TECHNICAL

FACTORY DIRECTED MODIFICATION

ENG 24-01 | **CODE:** National | **DATE:** February 22, 2024

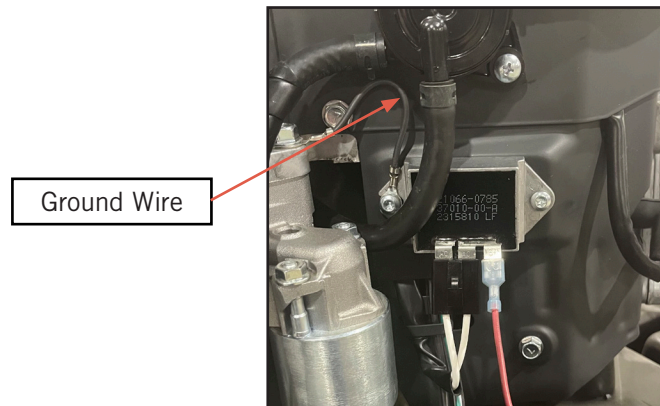
- If bar-code label does have a verification mark “●”, FDM has been completed on the engine. No further action is required.
 - If bar-code label does not have a verification mark “●”, continue to step 3.
3. Disconnect the Negative (-) battery cable.
 4. Disconnect the stator coil lead connector and B+ lead wire connector.
 - Below photo is an example and may not reflect your engine model or application.

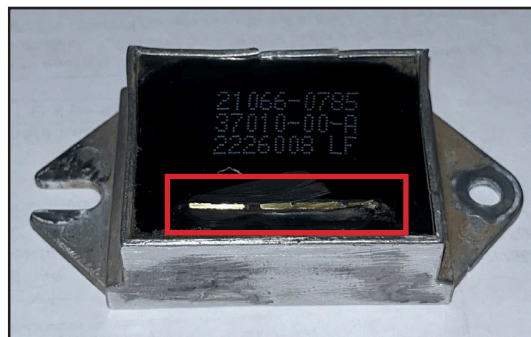
5. Remove voltage regulator mounting screw(s) and ground wire.
 - FH601D/FH680D/FH721D/FH770D: Only has 1 mounting screw and no ground wire.
 - FX751V/FX801V/FX850V: When installing Kit 99999-0934, discard 2 voltage regulator mounting bolts.
 - All other engines: Retain 2 voltage regulator mounting screw(s) or bolts.
 - Below photo is an example and may not reflect your engine model or application.

Loosen Bolts

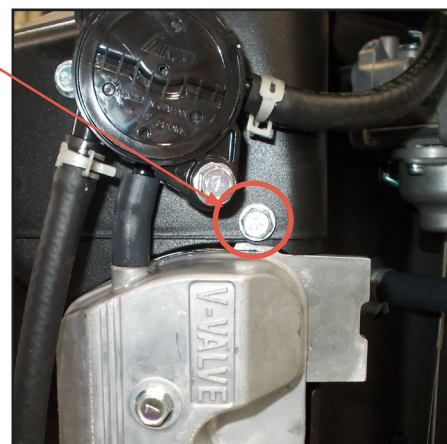
1. For FX751V/FX801V/FX850V engines, loosen (2) #1 cylinder head shroud bolts to allow for proper alignment of 21066-7017 voltage regulator lower mounting screw. For FX921V/FX1000V engines, go to next step.

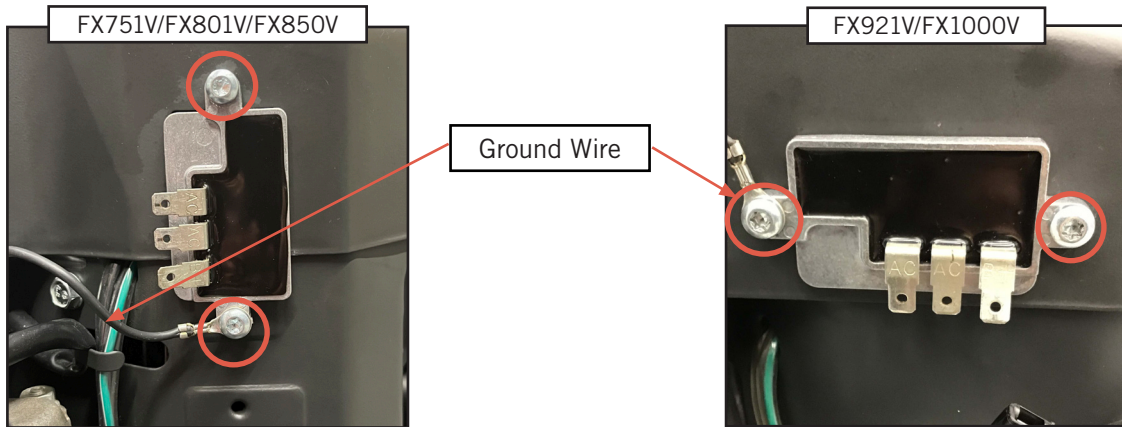
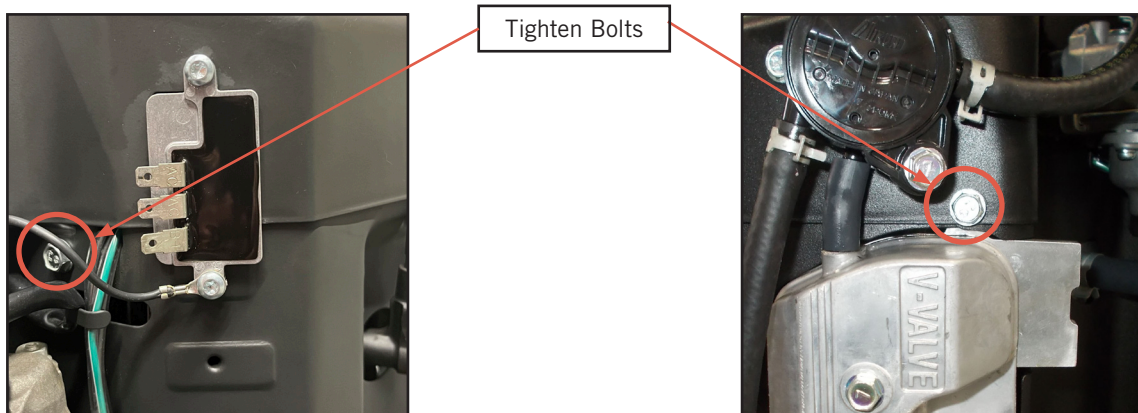
2. Install voltage regulator with ground wire.
 - For FX751V/FX801V/FX850V engines, Install voltage regulator and screws from kit 99999-0934.
 - For FX921V/FX1000V engines, Install voltage regulator 21066-7017 and retained mounting screws.
 - Torque voltage regulator mounting screws to 3.5 N-m (0.36 kgf-m, 31 in-lb).

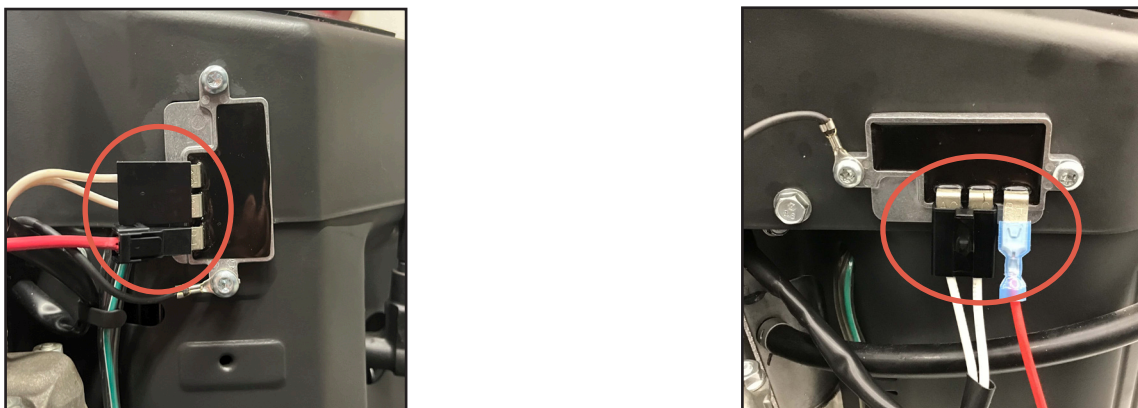
4. Apply automotive grade dielectric grease to the regulator terminals, then connect the stator coil lead connector and the B+ lead connector.

Dielectric grease must be applied to new 21066-7017 regulator terminals to ensure proper electrical contact and prevent corrosion.

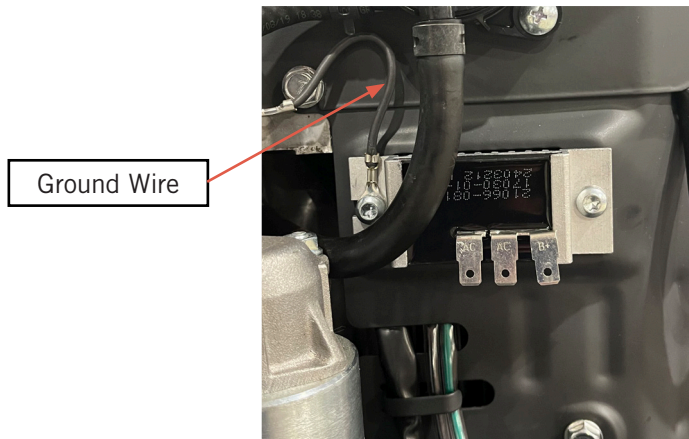
1. Install 21066-0810 Voltage Regulator with ground wire and tighten screw(s) or bolts.
 - FH601D/FH680D/FH721D/FH770D: Only have 1 mounting screw and no ground wire.
 - Below photo is an example and may not reflect your engine model or application.

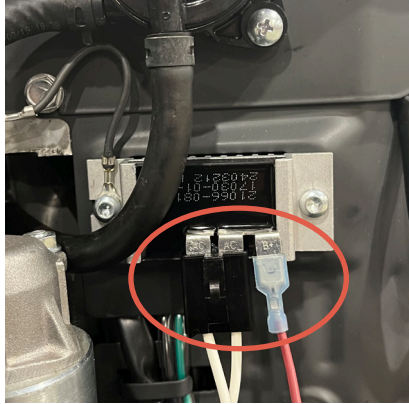
2. Compare your voltage regulator mounting screw(s) or bolts to the below, and torque to the listed specification.

No Torque

3.5 N-m
(0.36 kgf-m, 31 in-lb)

1.8 N-m
(0.18 kgf-m, 16 in-lb)
